August 8, 1988

Nuclear Regulatory Commission, Region III
Attn: Bruce S. Mallett, Ph.D.
Chief, Nuclear Materials Safety and Safeguards Branch
799 Roosevelt Road
Glen Ellyn, Illinois 60137

Response to your August 5, 1988, request for information on the use of cobalt for irradiation operations during the period of time that cesium WESF capsules are stored at our Westerville, Ohio facility is enclosed. Radiation Sterilizers is anxious to initiate operations at the Westerville irradiator as soon as possible; however, we share with the Nuclear Regulatory Commission, their concern that operations proceed in a safe manner.

FIGURE 1. Cross Section of Pool

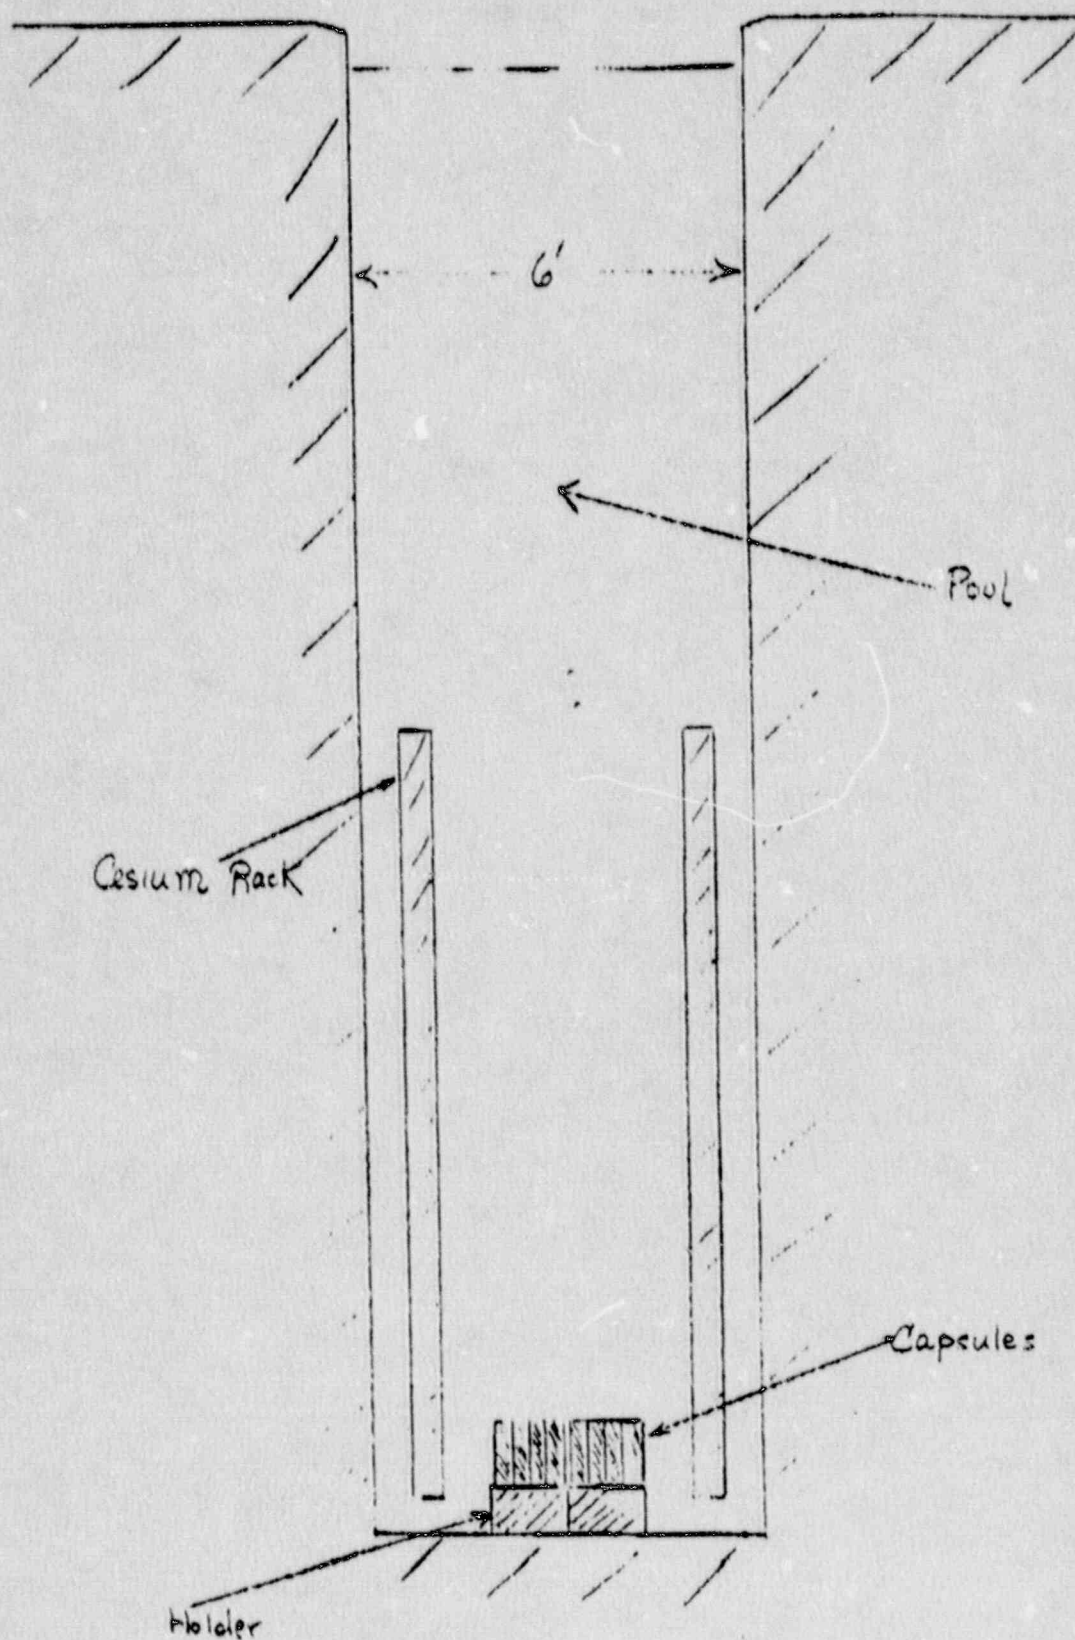
c. The holders will be centered between the two source racks with four of the holders being two abreast and the fifth residing by itself (see Figures 1 and 2). All of the holders will be positioned so that they are not on contact with each other. As described in an earlier letter to Region III (see attachment) the holders have a width of 14 inches and an overall length of 33 1/4 inches including the end tab.

The two source racks and their guide cables are centered 12 inches from the pool liner. The racks have an overall width of 5 inches, therefore, the inner dimension between the two source racks is 43 inches. Two holders positioned side by side and centered between the racks have an overall width of 28 inches. After allowance for a standoff distance of approximately 1 inch between the holders, the nearest distance between the racks and holders exceeds 6 inches. The nearest distance between the holders and the sides of the pool is 22 inches. One weld at the bottom of the pool runs along the centerline in the longitudinal direction; however, the holders can be positioned to avoid this weld.

FIGURE 2. Top View of Pool

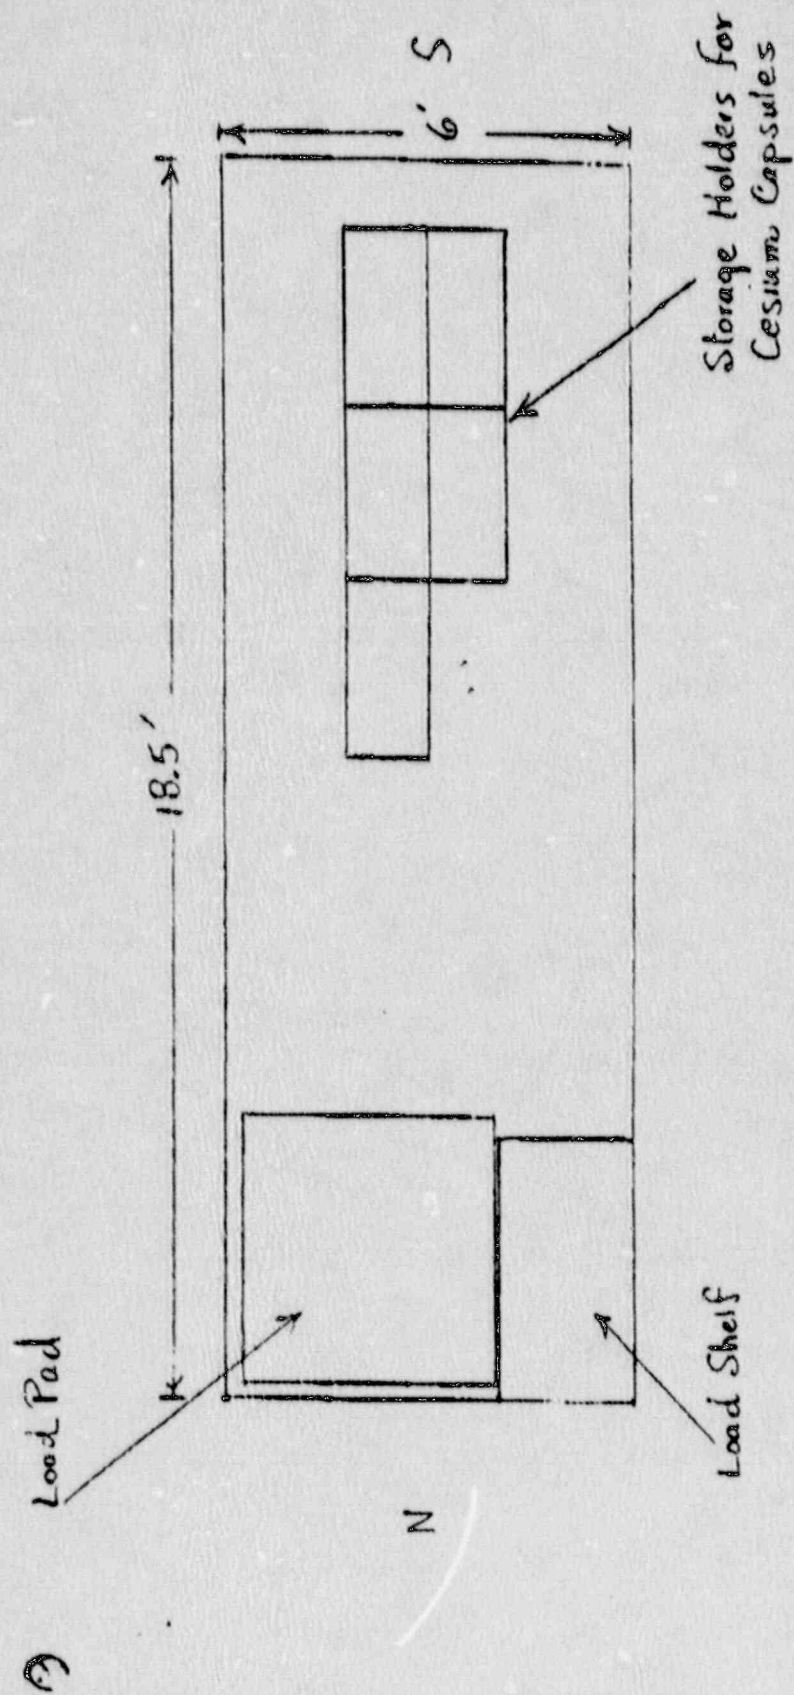
b. Casks containing the cobalt capsules will be lowered onto a 4 foot by 4 foot load pad that is located on the bottom of the pool at its north end. (see Figure 2). All off loading of cobalt capsules from the casks will occur at this location.

The holders containing cesium capsules will be at least 4 feet away from the load pad and load shelf. Transfer of the cobalt capsules from the source cage to the rack modules is performed on the load shelf. The rack modules are then dispersed in the cesium racks. These racks have six vertical locations for storage of isotope. All of the modules will be dispersed in a single horizontal row of baskets that are the fourth ones from the bottom of the racks. These baskets are

Figure 3. In Line Monitor

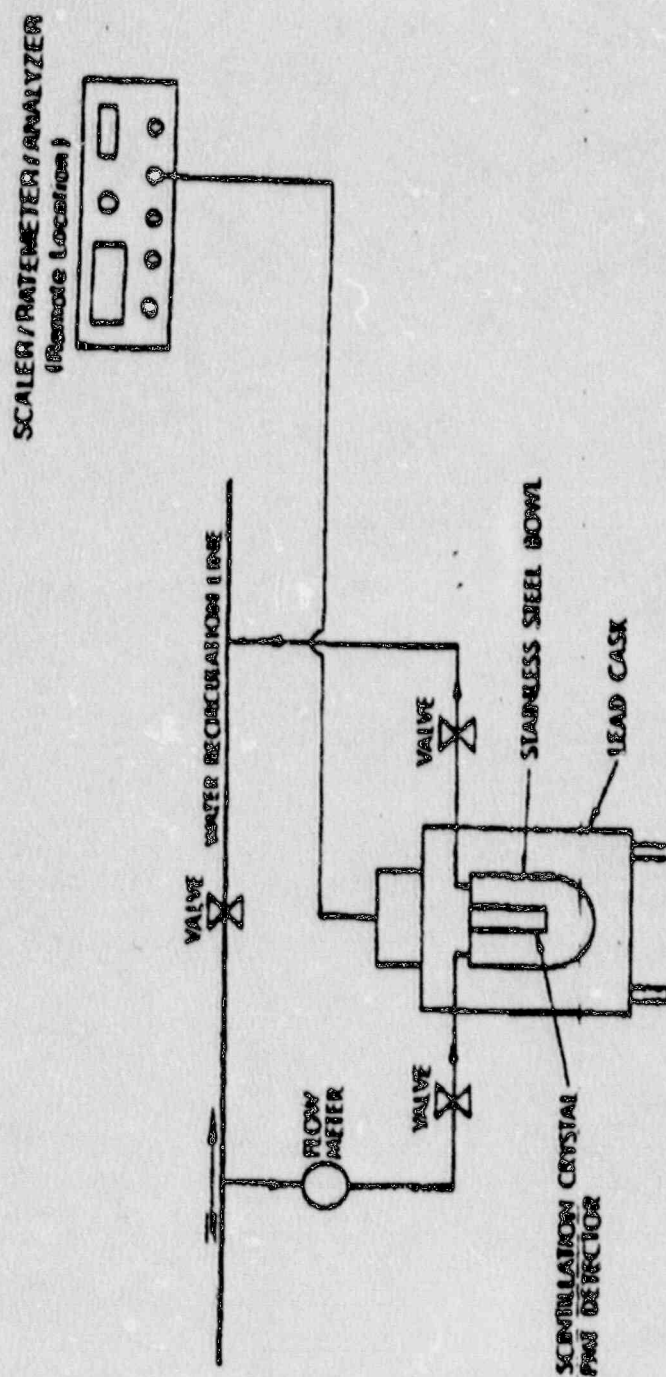
e. The in-line monitor shown in Figure 3 is designed to monitor the pool water whenever the water recirculation system is active. A fraction of the recirculated water is directed through a specially designed stainless steel canister that is contained within a 4 - pi lead shield (3 inches thick). The water is directed into the bottom of the canister where it mixes and through swirling action eventually exits through a port located at the top of the canister. The sensitive element of the system consists of a 2-inch diameter by 2-inch high sodium iodide scintillation crystal coupled to a 2-inch diameter photomultiplier tube. The output of the photomultiplier tube is fed into a rate meter / scaler / single channel analyzer. The detector high voltage and analyzer window are set for optimum detection of the photon energy of interest, i.e., cesium-137. The combination of shielding and energy discrimination permits detection of radioisotopic concentrations down to about 2×10^{-4} M ci per cubic centimeter of water. At this sensitivity, less than 20 M ci of radioisotope uniformly dispersed in 20,000 gallons of water could be detected. The system has the following specifications:

FIGURE 4. Calibration Geometry

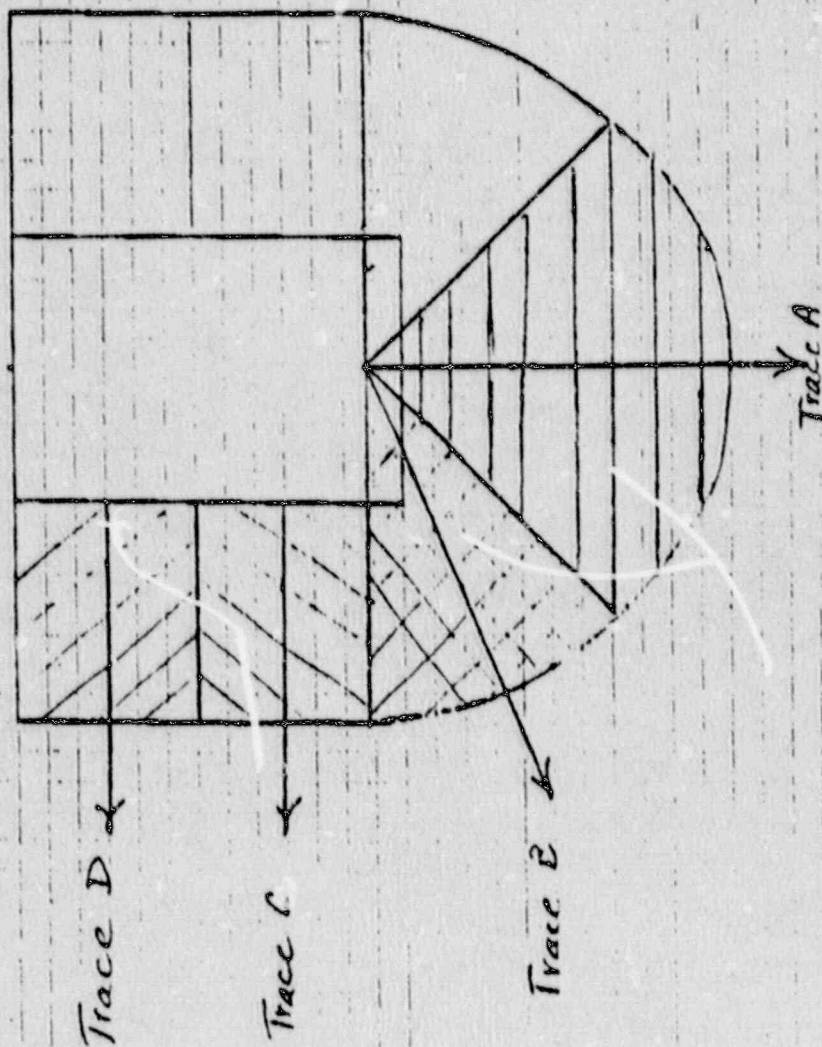
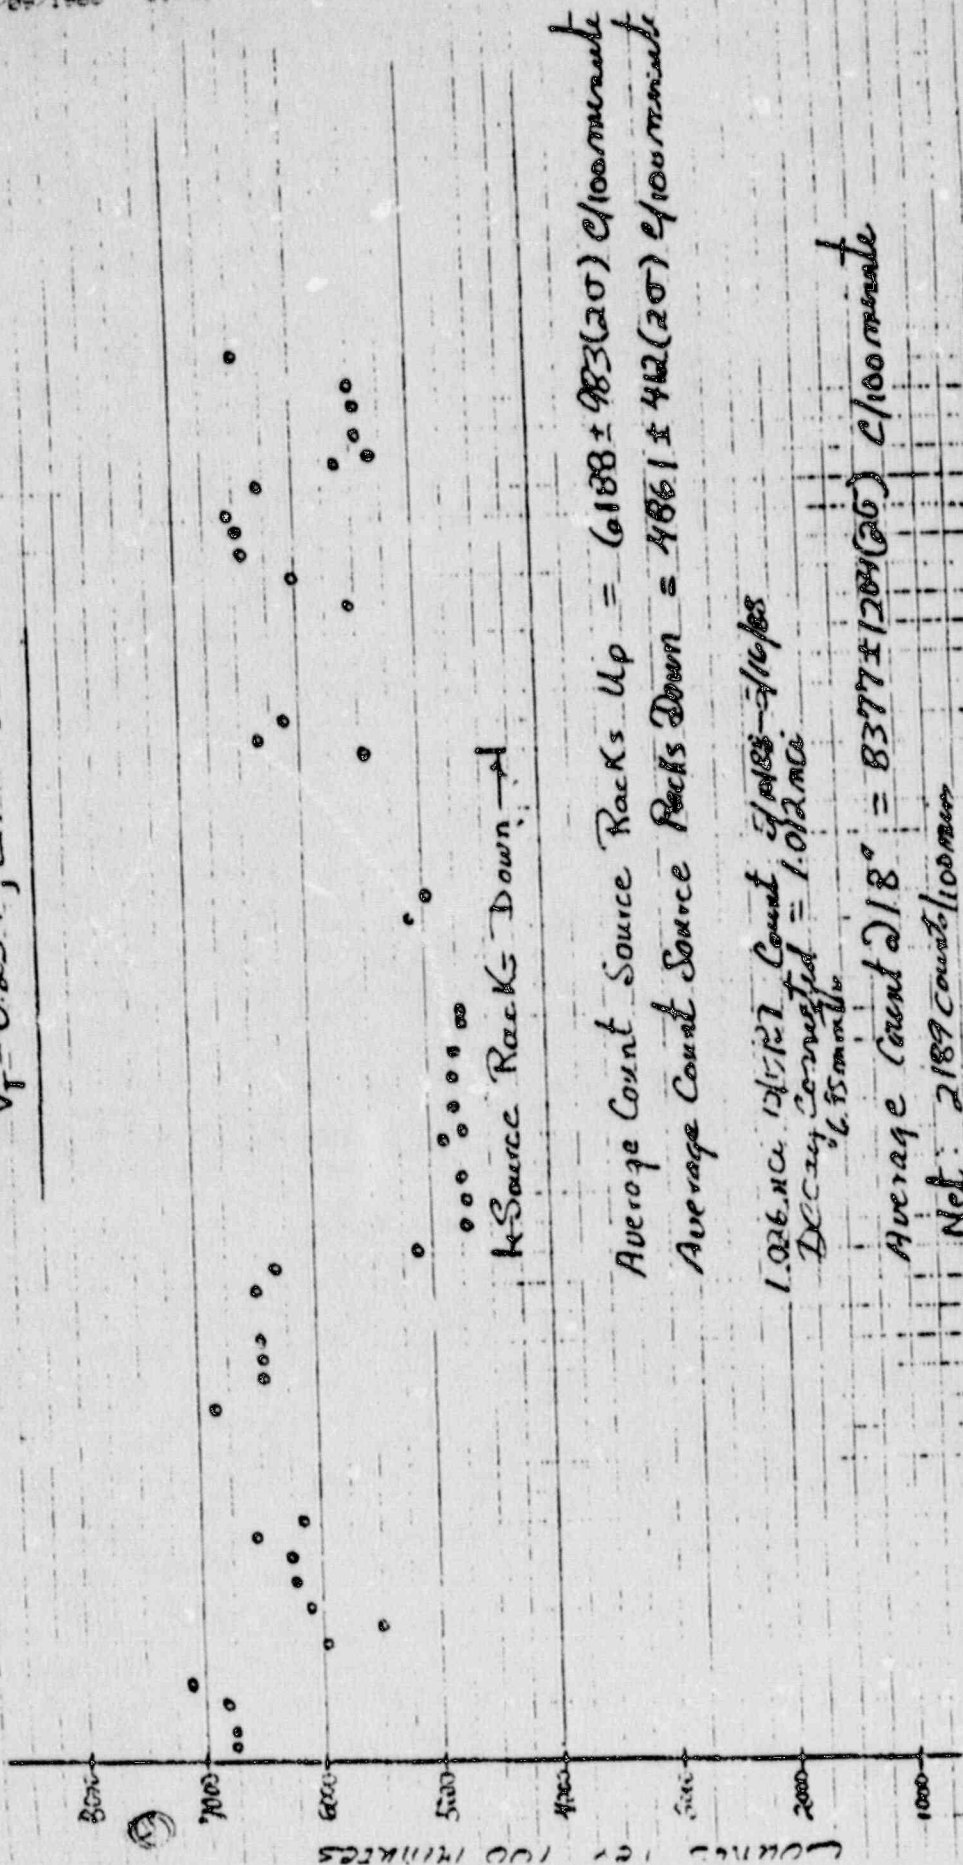
A one nanocurie cesium-137 source was used to calibrate the in-line monitor. The canister volume was first divided into several geometric regions and then source counts were taken as a function of radial distance from the crystal for each one of these regions. The geometric regions used in the analysis and radial traces where counts were taken are shown in Figure 4. Because the canister exhibits azimuthal symmetry upon rotation about Trace A, it was not necessary to generate radial traces in the unhatched regions. The volume of each geometric region was determined and then divided into several radial slices.

The counts observed along each radial trace were weighted according to the fractional volume in each slice. In this manner it was possible to obtain a volume weighted average count along each trace. These counts were subsequently weighted by the fractional volume in each geometric region thereby giving one average count that was representative of the count that would be observed if one nanocurie of cesium were uniformly dispersed in the canister. This count is duplicated when the cesium source is located along Trace A at a distance of 1.8 inches from the crystal. Counts taken at this location gave a value of 8377 counts per 100 minutes with a statistical scatter of ± 120 at 2.0 G. Background counts also were taken over several days. These numbers are shown in Figure 5. From a comparison of these numbers, it is obvious that one nanocurie of cesium activity is easily discernable above background. Since the canister holds one gallon of water or 3785 milliliters, the detector system is capable of detecting down to 2.6×10^{-7} M ci per milliliter of water.
